THE FIRST CHURCH OF CHRIST, SCIENCE

Proposed Accessible Entry BLC Hearing

October 26, 2021

BLC Suggestions

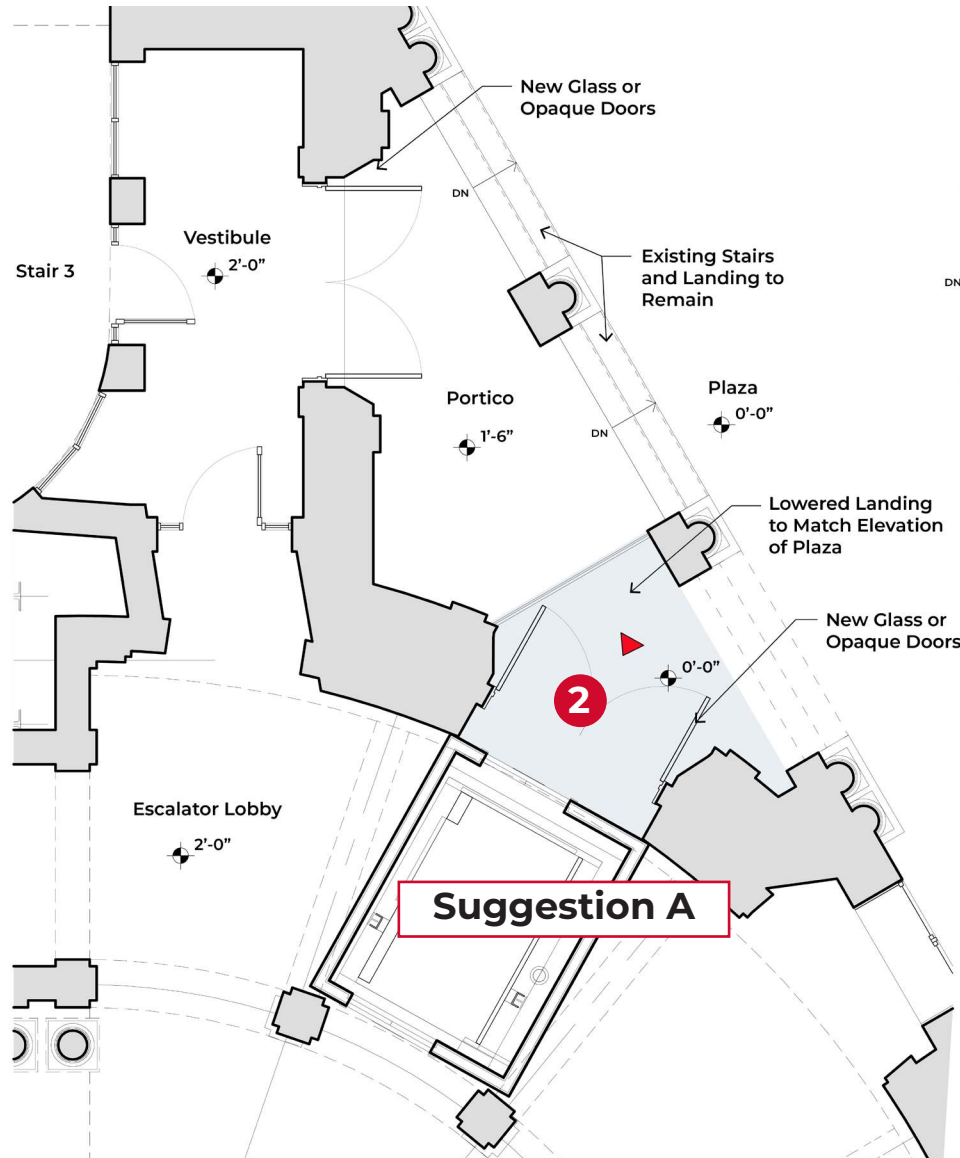
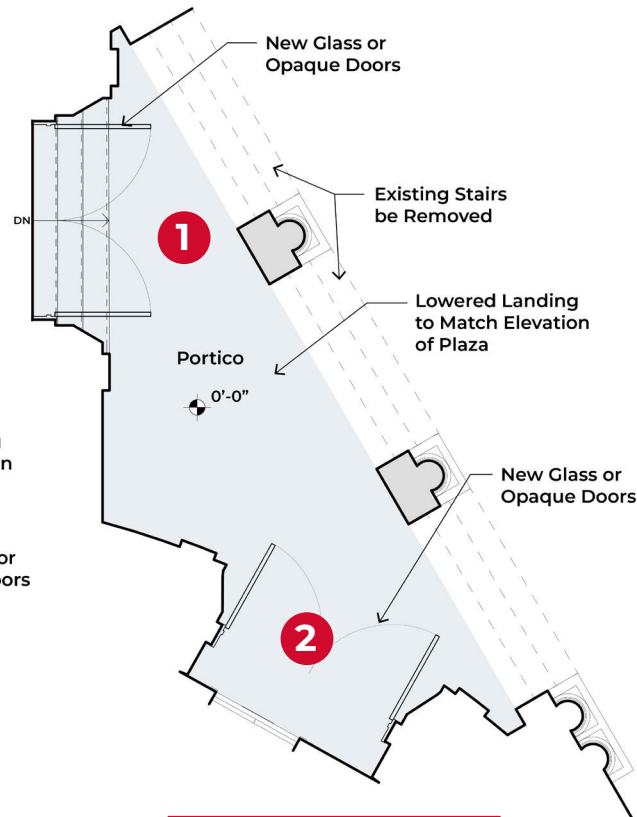
1 Lower Entire Portico:
Lowering the portico and placing stairs directly adjacent to the egress doors without a landing is not code compliant.

2 Add Doors in Front of Elevator:
Doors located at an accessible entrance must comply with code and be located 48" min from the elevator doors. Given the geometry of the portico, this is not feasible.

Required Adjustments to Make BLC Suggestions Feasible

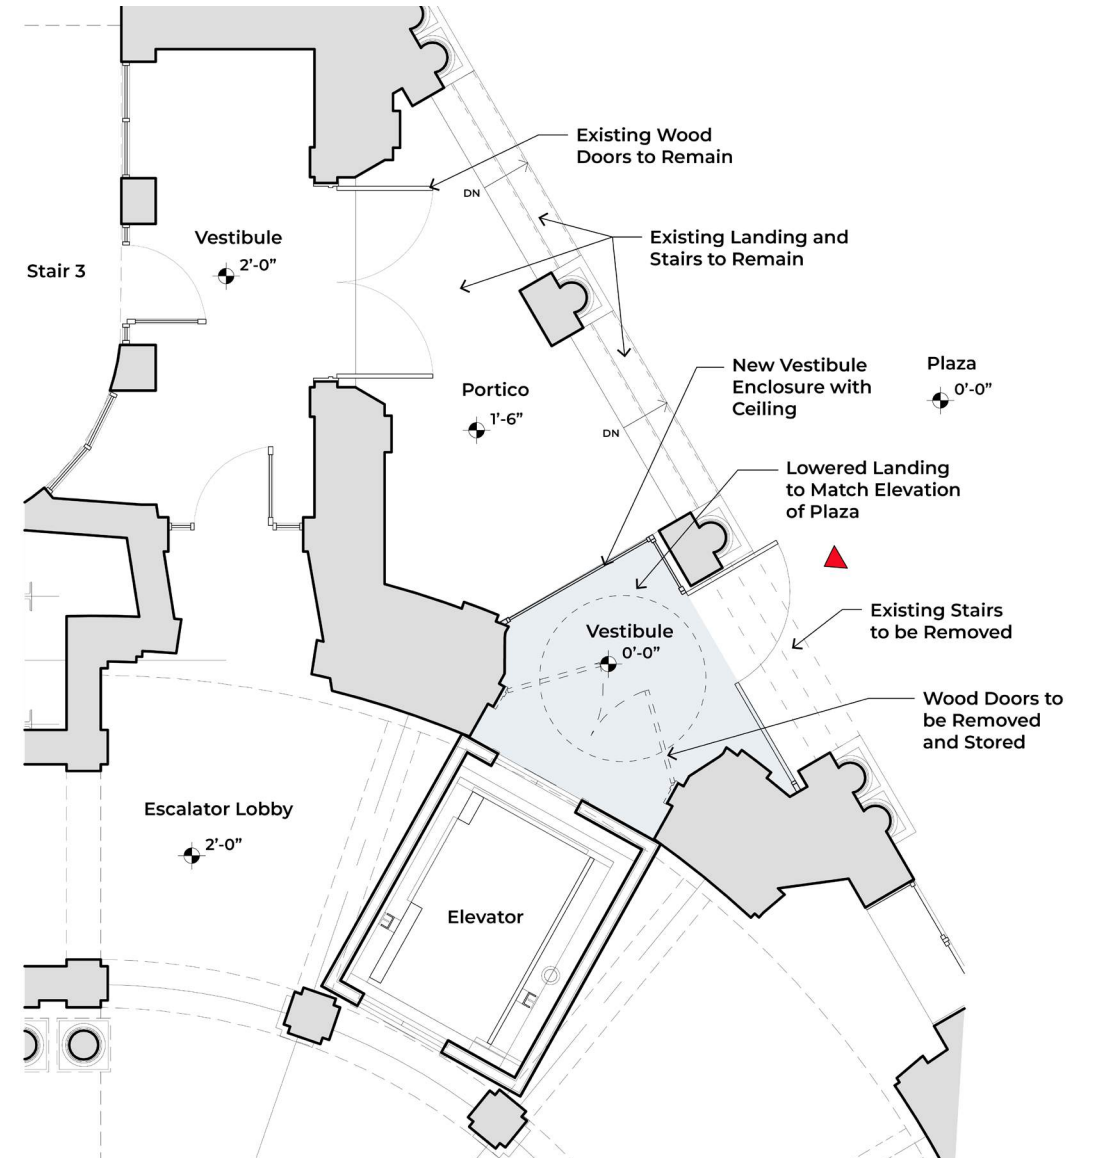
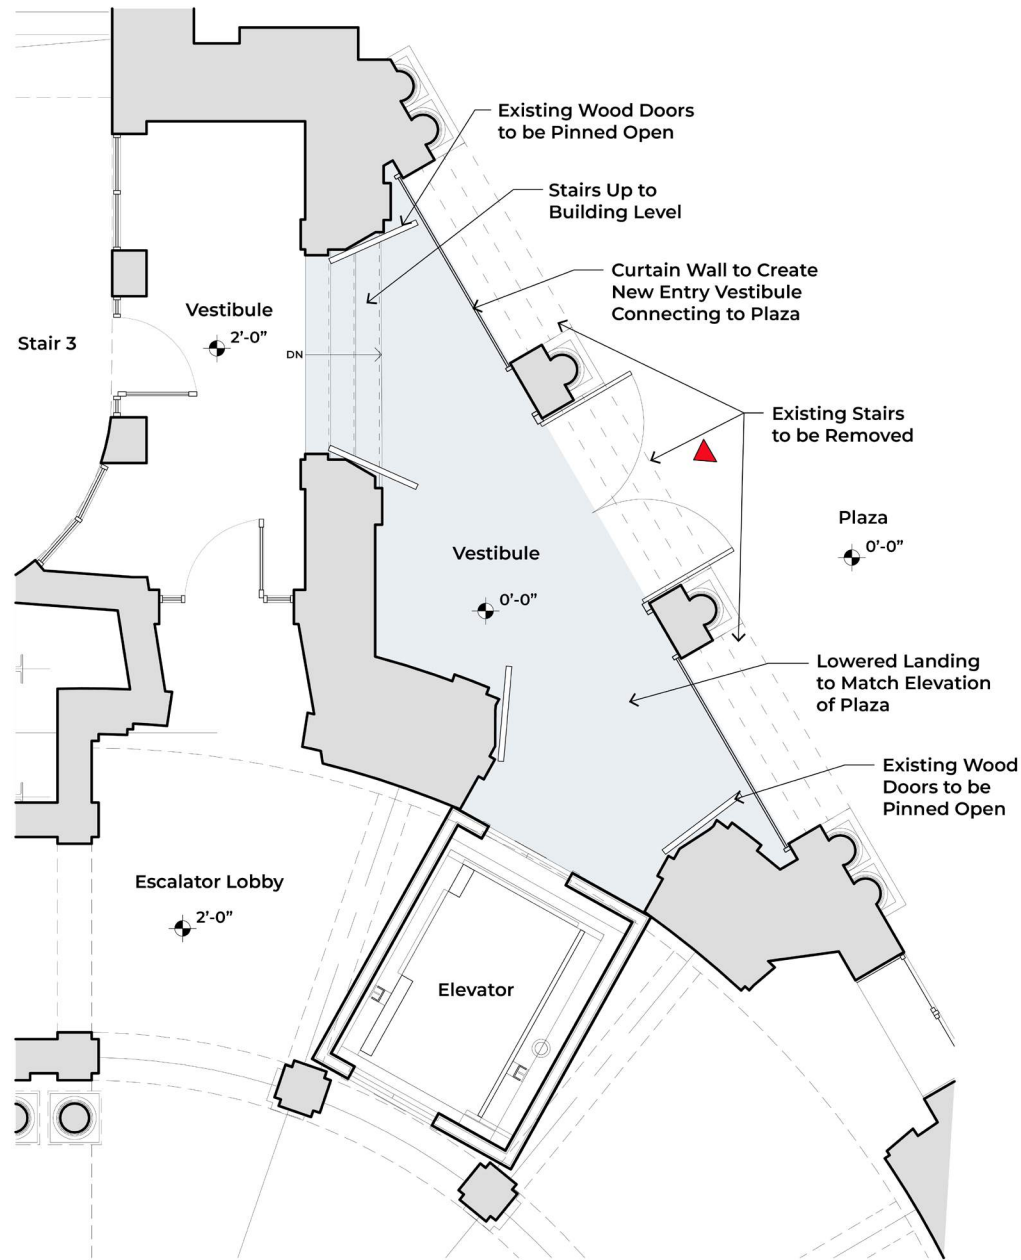
- Lowering the portico and placing stairs directly adjacent to the egress doors without a landing is not code compliant.
- Suggested glass doors just in front of elevator doors do not provide required clearances and is not code compliant.
- Exterior exposed elevator is not recommended by elevator expert consultant.
- New vestibule would require permanent alterations to the existing stone facade detail.

Frame Attachments to Existing Stone
Required Adjustments

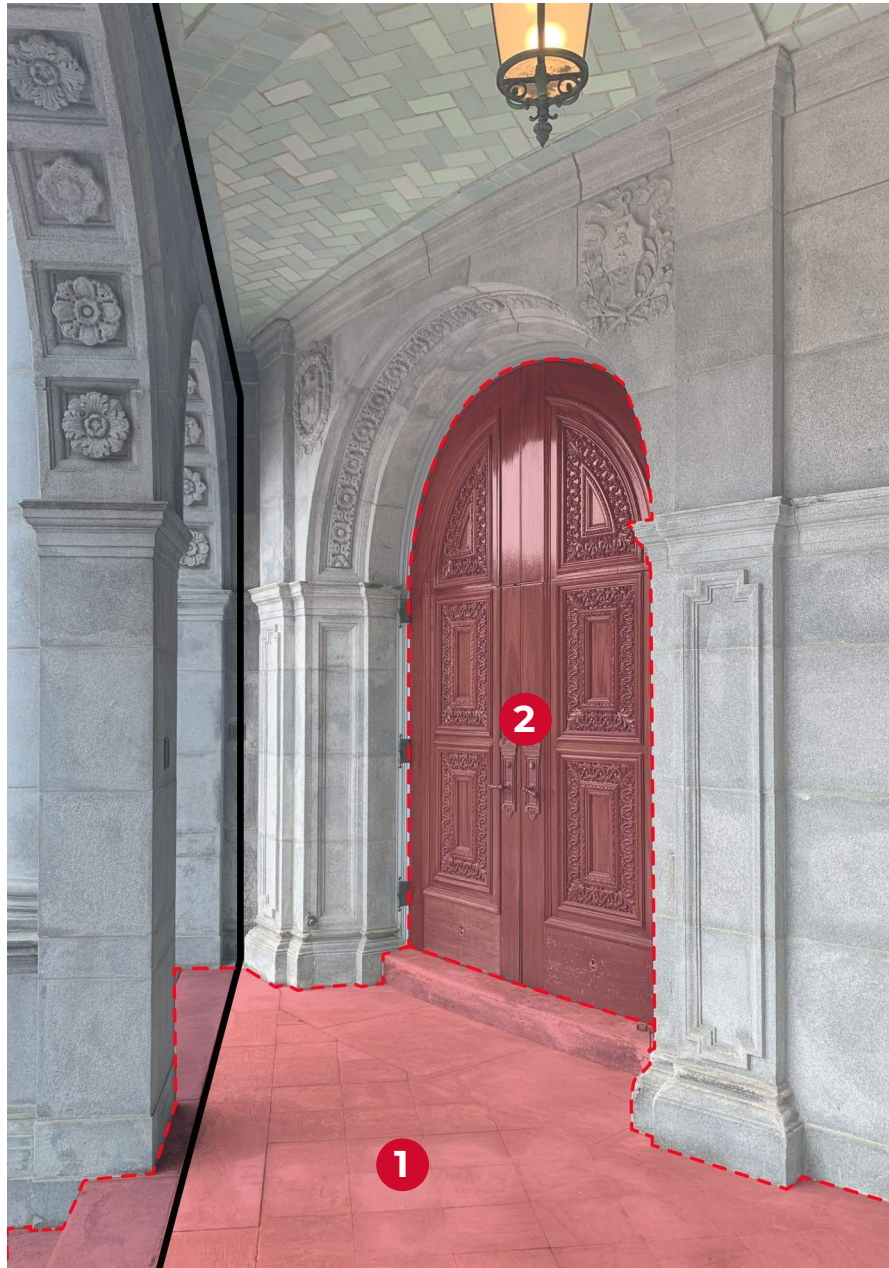
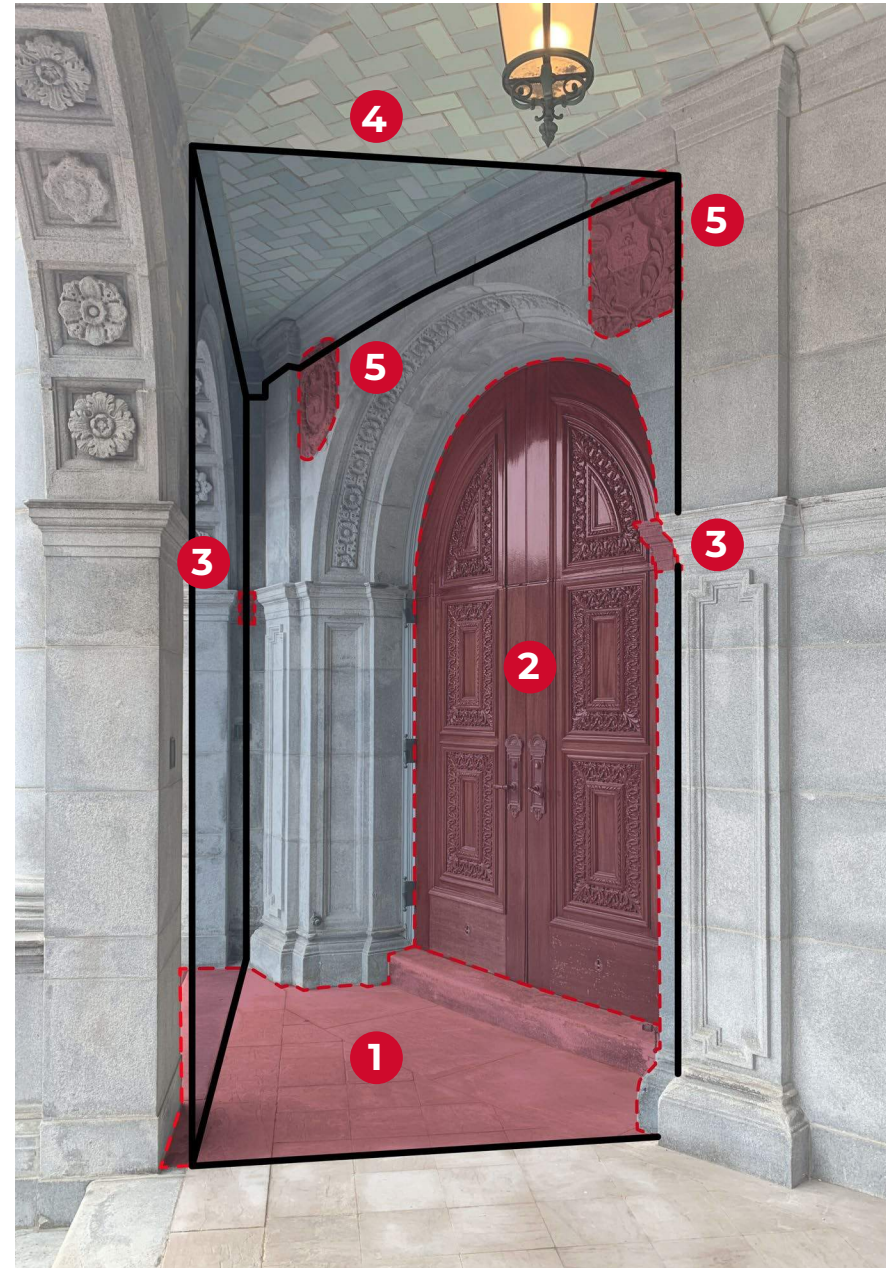
- 1 Portico landing to be lowered to match the elevation of the plaza.
- 2 Existing wood doors to be removed and stored.
- 3 Section of capital would need to be removed for vestibule attachment.
- 4 Arched Guastavino tiled ceiling to remain as existing.
- 5 Medallions carved into the stone would need to be removed.
